STAFF RECOMMENDATION
117 Bowling Avenue
October 21, 2020

Application: New Construction—Infill and Outbuilding
District: Richland-West End Neighborhood Conservation Zoning Overlay
Council District: 24
Base Zoning: RS7.5
Map and Parcel Number: 10405025600
Applicant: Chris Goldbeck
Project Lead: Melissa Baldock, melissa.baldock@nashville.gov

SPECULATIVE RESIDENCE
 117 BOWLING AVENUE
 NASHVILLE, TN

FRONT ELEVATION
SCALE: 1/4" = 1'-0"

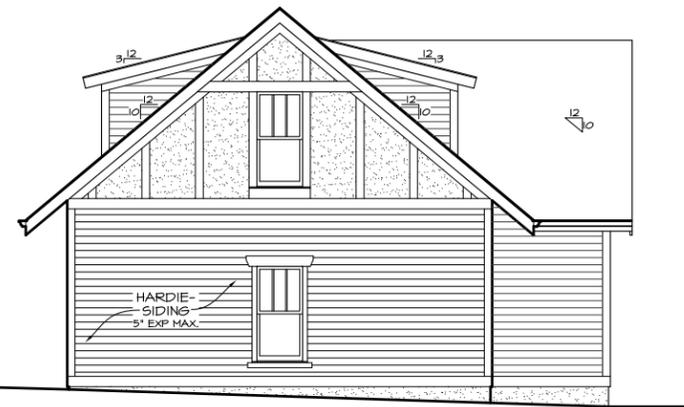
Roof form: The infill’s primary roof form is a side gable with a 7/12 slope. The wrap-around front porch will have a lower gable, also with a 7/12 slope. The front dormer will be gabled with a 5/12 slope; it is inset two feet (2’) from the wall below to meet the design guidelines. The rear portion of the house will be a 10/12 gable with 3.5/12 shed roof dormers. These dormers are inset 2’ from the wall below, as required by the design guidelines. The infill’s roof forms are typical roof forms found in the immediate historic context, and meet the design guidelines.

Orientation: The house is oriented to face Bowling, Avenue, which is appropriate. Its wrap-around front porch is at least six feet (6’) deep. The site plan does not show a walkway from the sidewalk to the front porch, and staff recommends that one be included. Vehicular access to the site will be via the rear alley, which meets the historic context.

With the inclusion of a front walkway, staff finds that the infill’s orientation to meet Section II.B.1.f. of the design guidelines.

RIGHT SIDE ELEVATION
SCALE: 1/4" = 1'-0"

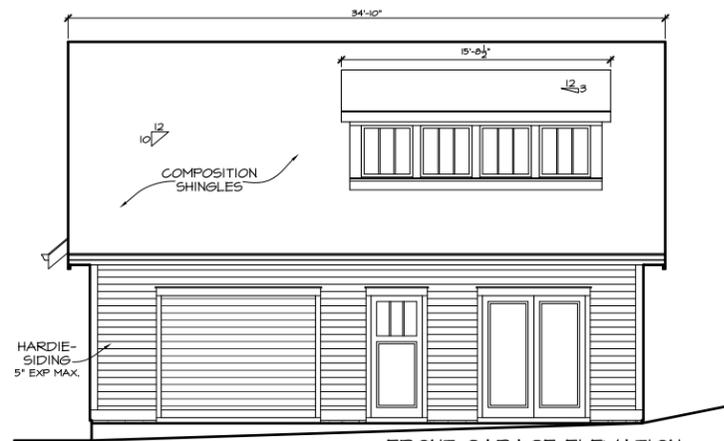
Proportion and Rhythm of Openings: The windows on the infill are all generally twice as tall as they are wide, thereby meeting the historic proportions of openings. There is one

expanse of approximately twenty-two feet (22') without a window or door opening on the right façade. Staff finds this expanse to be acceptable because it is in the back half of the house and is not on the side street elevation. This expanse will not be highly visible from the street.

Staff finds the infill's proportion and rhythm of openings to meet Section II.B.1.g. of the design guidelines.
